DRAWING AMENDMENTS:

REMARKS

Appendix A

(Marked up Sheet Showing Change to Figure 4)

Fig.4.

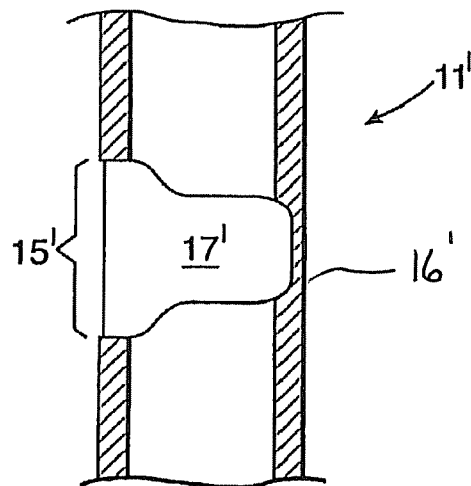
The examiner objected to the drawings for failing to include a reference numeral 16'.

ADD
NUMERIC
DESIGNATION
16'

Figure 4 is amended herein to include the reference numeral 16'.

The examiner's objection is overcome by amending Figure 4 herein to include reference numeral 16'.
